Bridge Replacement  
BRF-005-4(78)--38-91

PLANS OF PROPOSED IMPROVEMENT ON THE  
**PRIMARY ROAD SYSTEM**  
**WARREN COUNTY**  
Bridge Replacement  
South River 0.2 mi N of Co Rd S31 (NB)

PRELIMINARY PLANS

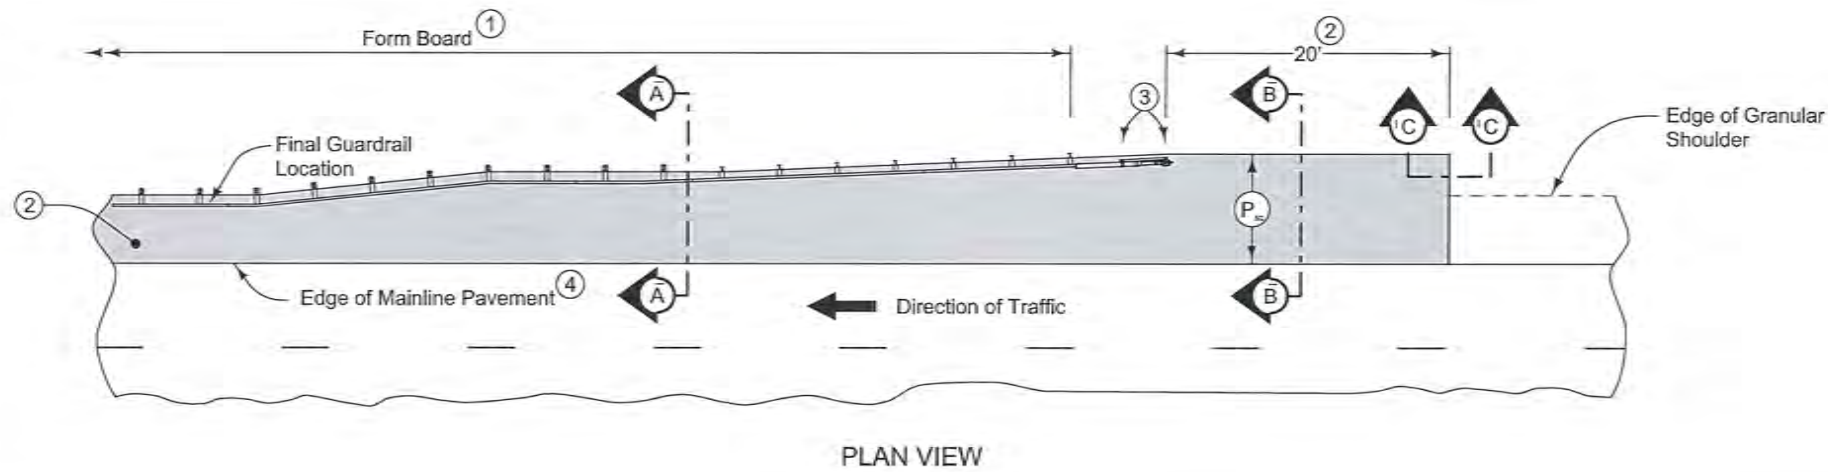
*Paving limits to change to locate tie-ins mid-panel existing pavement*
